SERVICE BULLETIN

Replacement of circlip (carburetor) for ROTAX® Engine Type 912 and 914 (UL Series)

ATA System: 73-00-00 Fuel system

MANDATORY

Fig. 5

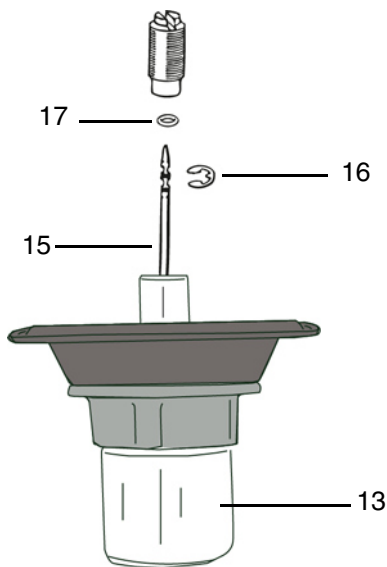
Step	Procedure
6	Remove jet needle (15) with circlip and O-ring from piston assy. (13).
7	Remove original O-ring (17) and circlip (16) from the jet needle (15) and discard. NOTE: Take note of the circlip's original needle position.

See Fig. 6.

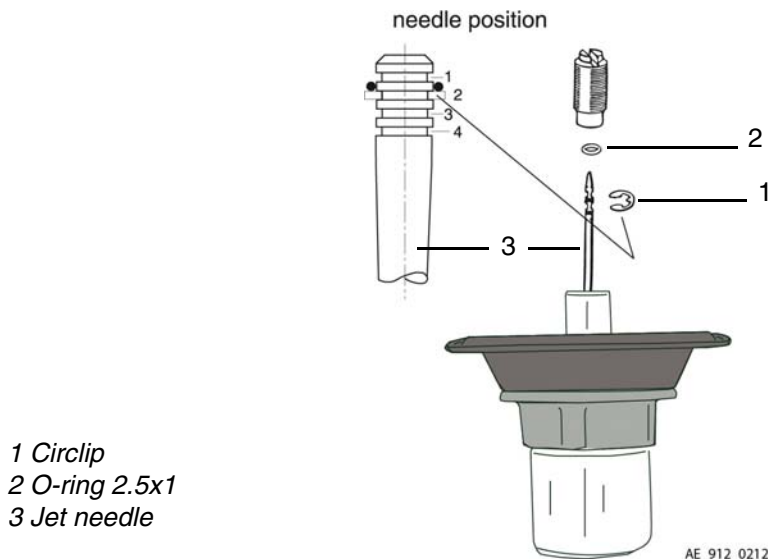
Step	Procedure
1	Place a new circlip part no. 945786 (1) into the same needle position. Place a new O-ring 2.5x1 part no. 950430 (2) over the jet needle (3).
